SERVICE BULLETIN: JSB031

Issue: 3

Subject: Engine Through Bolt Replacement and Upgrade

Affected Models: Jabiru 2200 & 3300 Engines in FLIGHT TRAINING

Figure 2: Bolt torques.

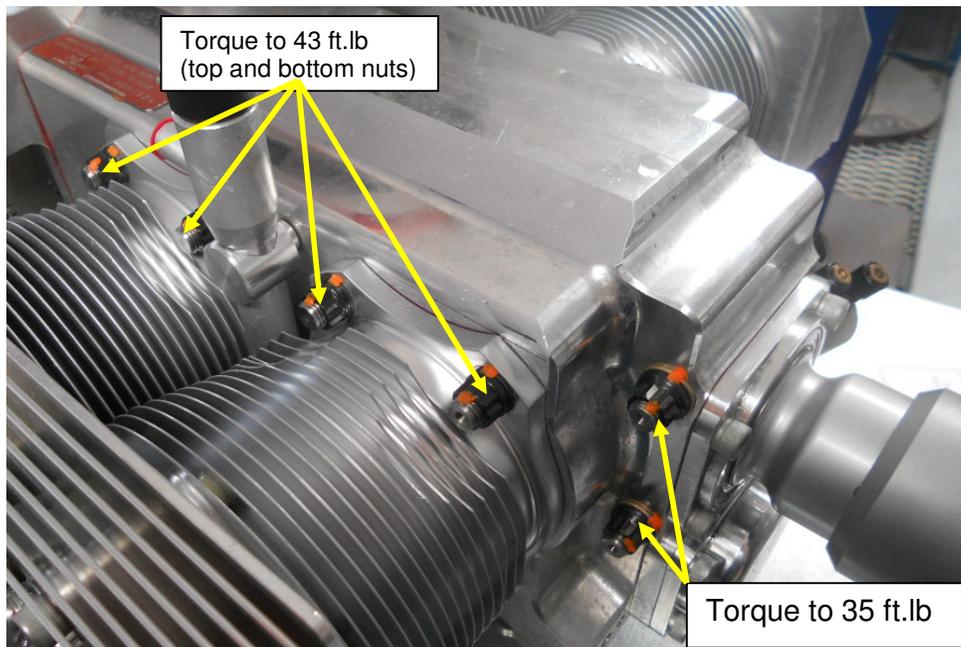
At the next 25hrly service, check the torque setting of 12 point nuts with a calibrated torque wrench. Prior to checking the torque, conduct crankshaft friction test as per section 6.2. If the torque was found to be less than 43 ft/lbs they should be retorqued to 43 ft lbs, if they are less than 43 ft lb. Reapply torque seal. Please see Figure 2.

Only loosen and change the nuts/washers on one bolt at a time. Then torque to 43 ft lb before undoing the next bolt. This will avoid losing too much clamping force of the case. If a locking compound was used on the bolt/nuts, threads must be cleaned before nuts are refitted. Once all bolts are done check the torques and apply torque seal. Please see Figure 2.

- The latest through bolt configuration of 7/16" through bolts and studs, 12 point ARP nuts and hardened steel washers all installed without thread locker to a torque setting of 43ft.lb (35ft.lb for the front two short studs) has been developed to increase the life of the through bolts of engines used in flight training.

- 3/8" bolts **should not** be torqued to 43 ft.lb, they are currently torqued to 35 ft.lb. Don't be tempted, this will generate excessive bolt tension!
